## PRODUCT SUPPORT BULLETIN BULLETIN NO. 338

MACHINE: **M3 with Lag Screw Driving Module  
Two-Tie Screw Spiker**

SUBJECT: **Breakaway Style Pusher Block Assembly – 98400003**

**Pusher Block Assy. - 98400003**

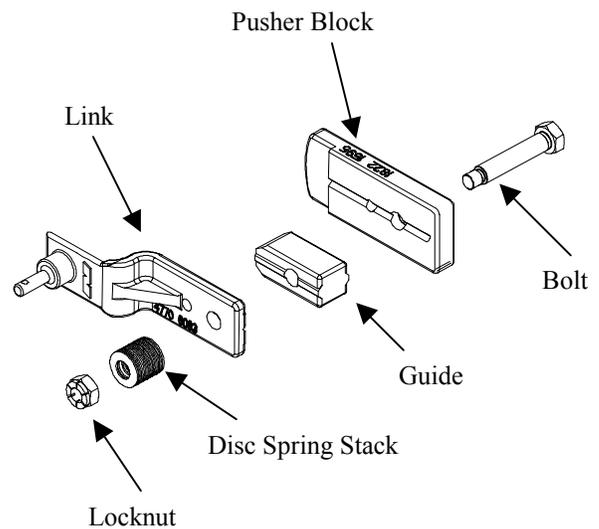
The Lag Screw Driver Pusher Block, p/n 18221579 has been replaced with a breakaway style assembly. The original pusher block used a coiled spring pin to keep the pusher block properly aligned. If the lag driver was extended before the pusher block retracted completely, the socket would force the pusher block down and the coiled spring pin would break. The pin would then have to be replaced.

The breakaway pusher block eliminates the coiled spring pin and therefore reduces maintenance of this piece. The new assembly is designed to pivot out of the way if the socket contacts the pusher block.

Please note that the original pusher block, p/n 18221579, and link, p/n 47706080, cannot be used with the Breakaway Guide, p/n 18221888.

However, the old guide, p/n 18221827, can be used with the new Breakaway Pusher Block and Link if the Coiled Spring Pin, p/n 3398738 and Capscrew, p/n 2774826 are used.
